## **T. E. HOUSTON SUBDIVISION**

APPLICATION NUMBER 4 DATE July 16, 2009  
APPLICANT T.E. Houston Subdivision  
REQUEST Subdivision

# DETAIL SITE PLAN

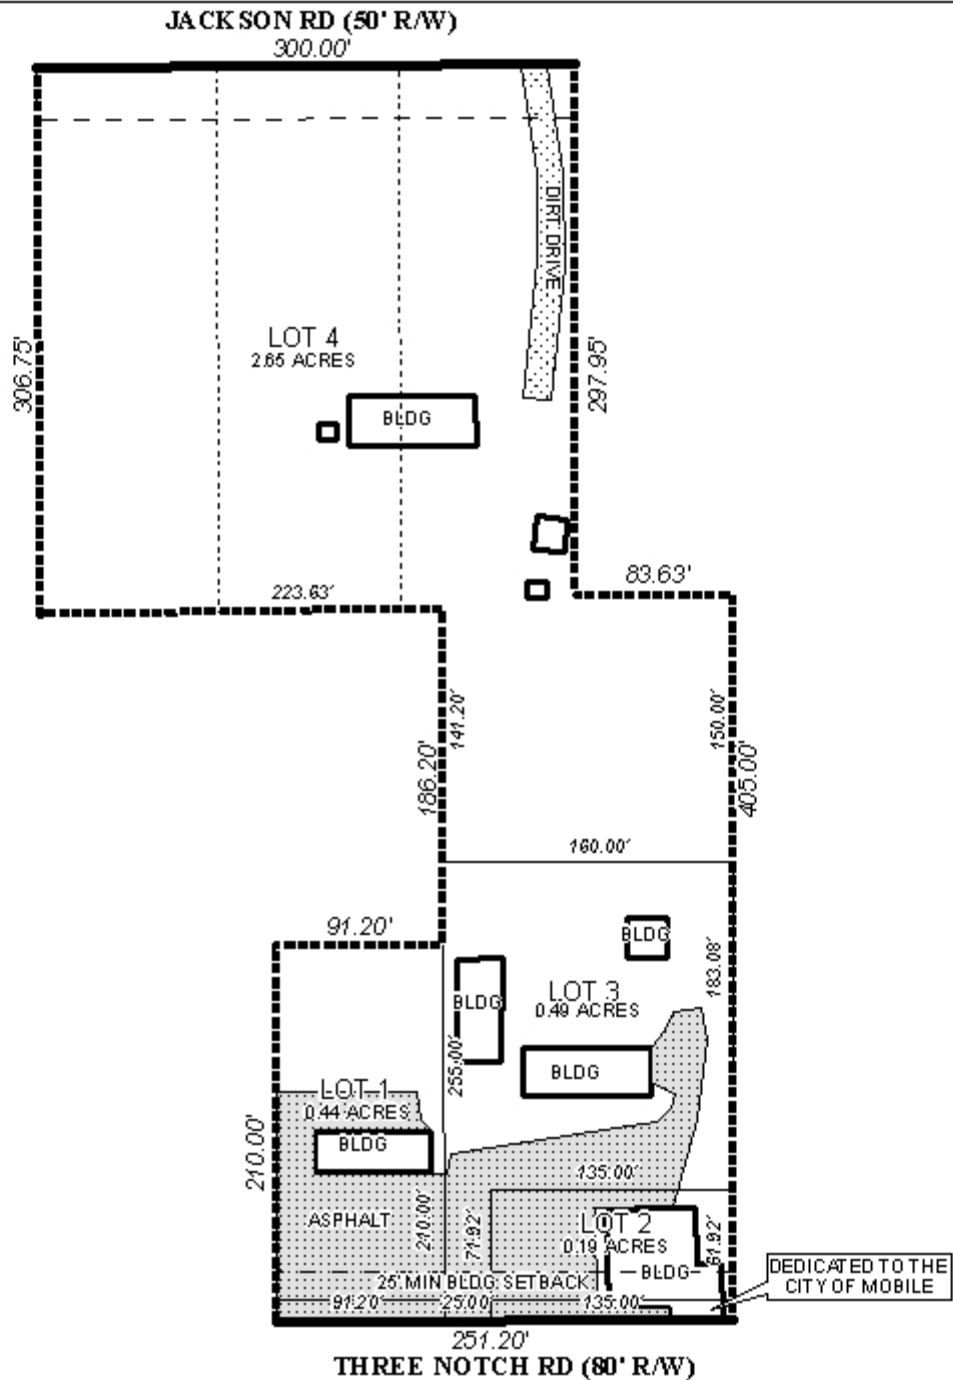
The applicant submitted a revised plat and description. The plat depicts the existing buildings and also shows a reduced number of proposed lots (4 lots are proposed instead of 6 lots).

The revised plat still shows a lot crossing the city limits line, and the applicant does not appear to address the concern raised by staff. Therefore, the applicant must complete the process through the City Council of bringing proposed Lot 4 fully into the city or fully out of the city prior to the recording of the final plat, if approved. If the lot is brought into the city, a rezoning application will be required to eliminate the split-zoned condition.

The proposed lot lines and their relationship to the existing buildings will create setback problems. Furthermore, shared access and parking is evident for these existing non-conforming businesses, thus a Planned Unit Development application will be required, and must be approved prior to the recording of the final plat. If the PUD application is not approved, a new application for Subdivision approval, with a redesign of the lots, will be required in order to eliminate the need for the PUD.

The applicant's justification for the flag lot, proposed Lot 3, is that they wish to sell the existing day care on the site, and that the shape of the lot accommodates the shared access between the businesses located on proposed Lots 1-3, thus it reflects an existing condition. Due to the existing development of the site, a lot solely for the day care would require some sort of flag shape, and the lot as proposed provides the minimum frontage for flag lots on a public street required by Section V.D.1. of the Subdivision Regulations.

Finally, Lots 1-3 share three access points onto Three Notch Road: these lots should be limited to the existing curb-cuts. Lot 4, which has 300-feet of frontage onto Jackson Road, should be limited to a maximum of two curb-cuts. The size, design and location of all new curb-cuts, or reconfiguration of existing curb-cuts, is subject to the approval of the respective jurisdiction (Mobile County Engineering or City of Mobile Traffic Engineering), and should comply with AASHTO standards.

- 1) City Council-approved inclusion or exclusion of Lot 4 from the city prior to the recording of the final plat ;
- 2) Rezoning of Lot 4, if brought into the city, to eliminate the split-zoning condition, prior to any applications for building or development permits for the site;

- 3) Elimination of shared access with the church site to the West, or inclusion of the church site with a Planned Unit Development application for Lots 1-3, to address shared access and reduced setback issues, with approval required prior to the recording of the final plat;

- 4) Placement of a note on the plat stating that Lots 1-3 are limited to the three existing shared-access curb-cuts onto Three Notch Road, and that Lot 4 is limited to two curb-cuts onto Jackson Road, with the size, design and location of curb-cuts subject to the approval of the respective jurisdiction (Mobile County Engineering or City of Mobile Traffic Engineering), and to be in compliance with AASHTO standards;

- 5) Dedication of right-of-way adequate to provide 50-feet from the centerline of Three Notch Road; and
- 6) Placement of a note on the final plat stating that new development, redevelopment, or change of use to commercial or multi-family must comply with the buffer requirements of Section V.A.8. of the Subdivision Regulations.
